REMARKS

QUALITY CONTROL IN DATA TRANSFER & STORAGE APPARATUS (30010276)

FIG. 1

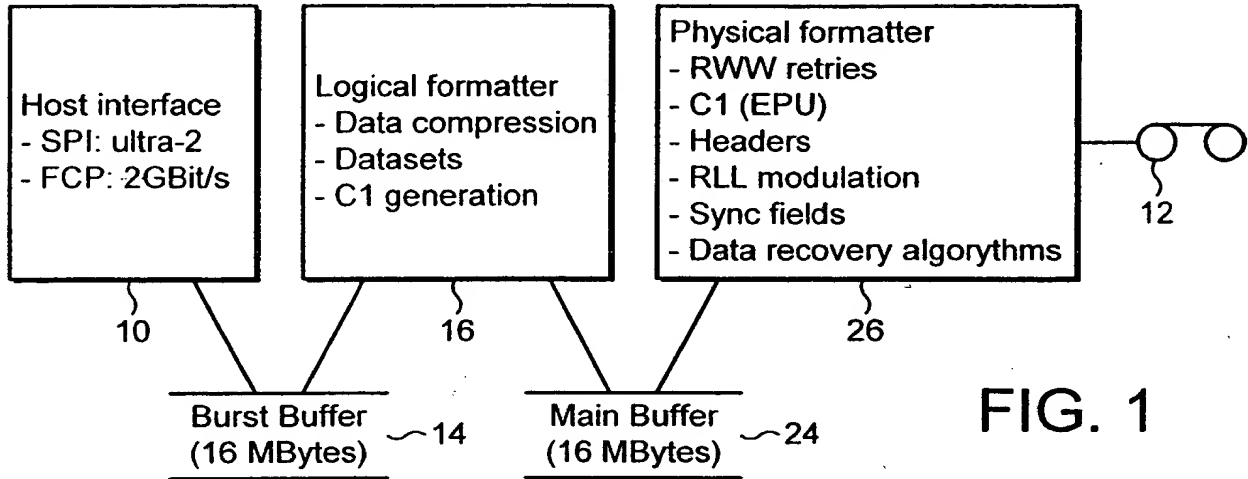
The Examiner is requested to approve changes to the Figures as indicated by red markings. The changes to the drawings enable the drawings to be consistent with the terminology employed in the specification of the application as filed. For example, the specification refers to codeword pairs as "CCP", but the drawings, as originally submitted, refer to the codeword pairs as "CP." Also, the term "CD" in box 32 should have been "CQ" as an inspection of the specification reveals.
